Docket Item # 12 BAR CASE #2009-0020

BAR Meeting March 4, 2009

ISSUE: Alterations and Signage

LOCATION: 320 King Street

Figure 7: Handicap lift details

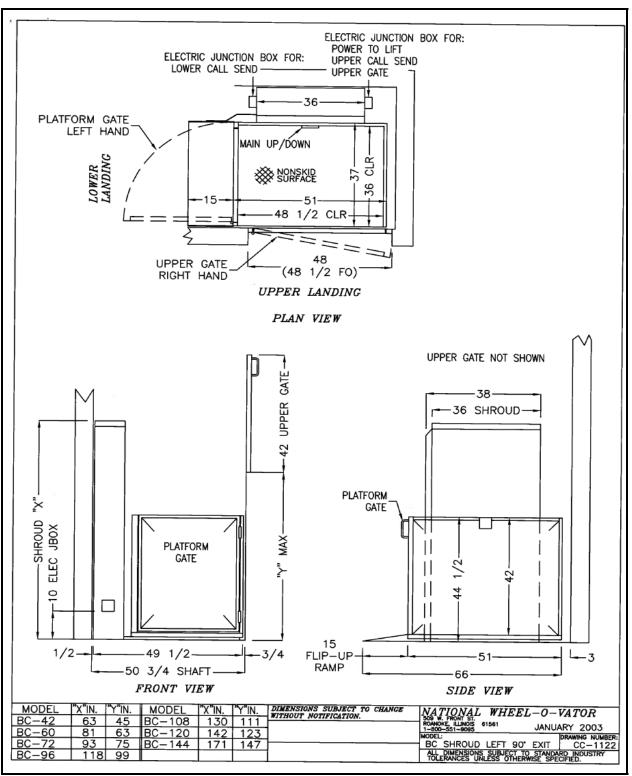
However, Planning and Zoning Staff and the City's Transporation and Environmental Services (T&ES) are concerned that the proposed new stoop and stairs will encroach into the right of way and impact accessibility around the new stoop and the adjacent tree well to the east. Prior to the current submittal, Staff met with the applicant's architect and discussed a proposal where the stoop would be altered, and the stairs re-oriented to a side-loaded stair towards the projecting bay window. While Staff understands and supports the need for a handicap lift and the need to alter the existing stoop, in order to accommodate the lift, Staff would recommend that the applicant explore other methods to achieve this aim without encroachment into the public sidewalk and defer until this situation is resolved.

Figure 9: Elevation and plan showing proposed alterations and signage

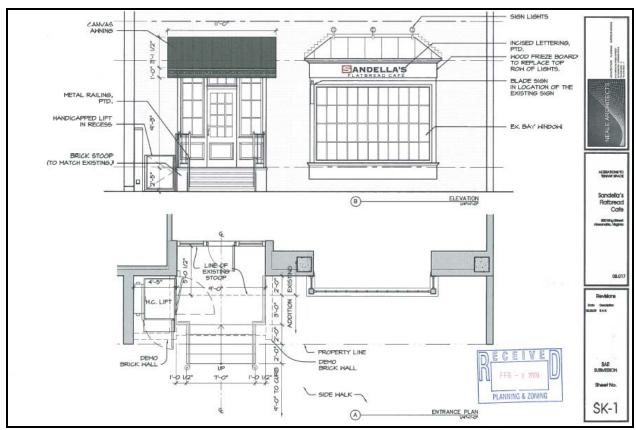
In respect to the proposed signage, the *Design Guidelin*es generally recommend one sign per business. In the opinion of Staff, the three proposed signs are excessive. Because this is a new restaurant and because this retail portion of 320 King Street is set back approximately 5' from the buildings on either side, Staff believes that two signs would be appropriate and recommends that the hanging sign be deleted. The frieze sign will be the most visible of the signs and the awning sign will help to announce the main entrance to the restaurant. Furthermore, the text and the color scheme of the hanging sign do not appear to stylistically relate to the awning and frieze signs.

- F-1 The applicant shall obtain a sign permit for the proposed sign and/ or wall lettering.
- C-1 Wall letters / signs must comply with USBC [H103-H111] Please indicate the method to be used for anchoring the letters to the wall.

- C-3 Awnings must comply with all applicable requirements of USBC 3105.3 and 3202.3.1 Retractable and fixed awnings must have a minimum 7 foot clearance form a sidewalk to the lowest part of the framework or any fixed portion of any retractable awning is required. Retractable awnings must be securely fastened to the building and can not extend closer than 24 inches in from the curb line (USBC 3202.3.1).

Staff recommends deferral of the application pending resolution of the proposed stoop encroachment into the public right-of-way and restudy of the proposed signage.

Figure 10: Proposed hanging sign

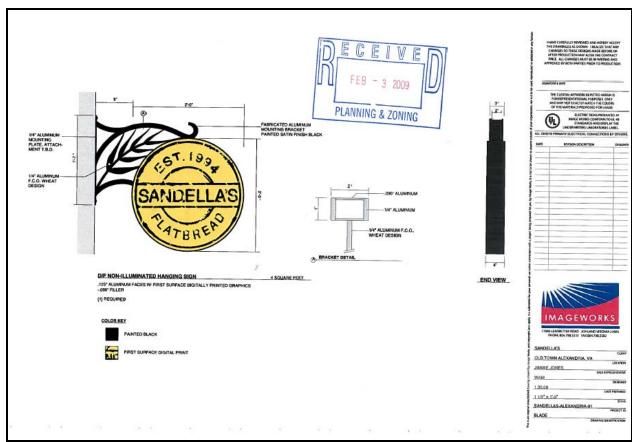
- C-2 Projecting, hanging signs must comply with USBC [H103-H107, H112] for type of materials, maximum projection, vertical clearance below all parts of the sign, and additional loads.
